DATE ~~R~~ Sep.11/03**V2500-A1/A5/D5 SERIES PROPULSION SYSTEMS NON-MODIFICATION SERVICE BULLETIN**

This document transmits Revision 4 to Service Bulletin EV2500-72-0316

Revise pass/fail criteria.  
 Include hints to avoid  
 spurious USI readings.

ENGINE – LP COMPRESSOR FAN BLADES – ULTRASONIC INSPECTION OF FAN BLADE ROOTS –  
NON-MODIFICATION SERVICE BULLETIN

Removal of Excess Dry Film Lubricant  
Figure 2

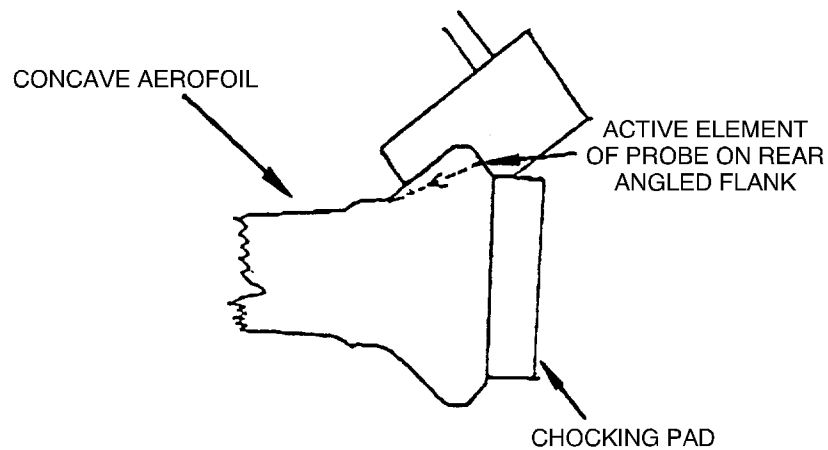
- R (b) Reject the blade if a signal greater than 60% screen height is produced between the 4.5 and 5.5 Division Lines on the time base.
- R (c) Subsequently to the above, if excess dry film lubricant is still  
R present at the ultrasonic reject indication position on the blade root  
R flank in the areas X and Y defined in Figure 2, remove this by lightly  
R rubbing with Scotchbrite (using CoMat 05-125 to 05-127). Repeat the  
R ultrasonic check as in (a) and (b) above. Reject the blade if a signal  
R greater than 60% screen height is still present between the 4.5 and  
R 5.5 division lines on the time base.

- 1) At the ultrasonic reject indication locations, on either the concave or the convex flanks, remove any excess Dry Film Lubricant (DFL) by lightly rubbing with 'Scotchbrite' using CoMat No 05-125 to 05-127 in the following areas:
  - above the top edge of the bedding (location X)
  - at the lower corner of the root where the ultrasonic probe locates (location Y)

**CAUTION 1:** On post SB 72-0375 and post SB72-0384 (Metco 58 coated root) fan blades it is essential not to "scotchbrite" the fan blade bedding surface (Location Z) as this will have a detrimental effect to the coating.

- 2) If excessive DFL is present, at location X and/or Y that cannot be removed by lightly rubbing with 'Scotchbrite' it is permissible to remove this using a non metallic scraper and then remove any loose residual DFL using 'Scotchbrite'

**CAUTION 2:** On post SB 72-0375 and post SB72-0384 (Metco 58 coated root) fan blades it is important not to damage the fan blade bedding surface (Location Z) when using a scraper
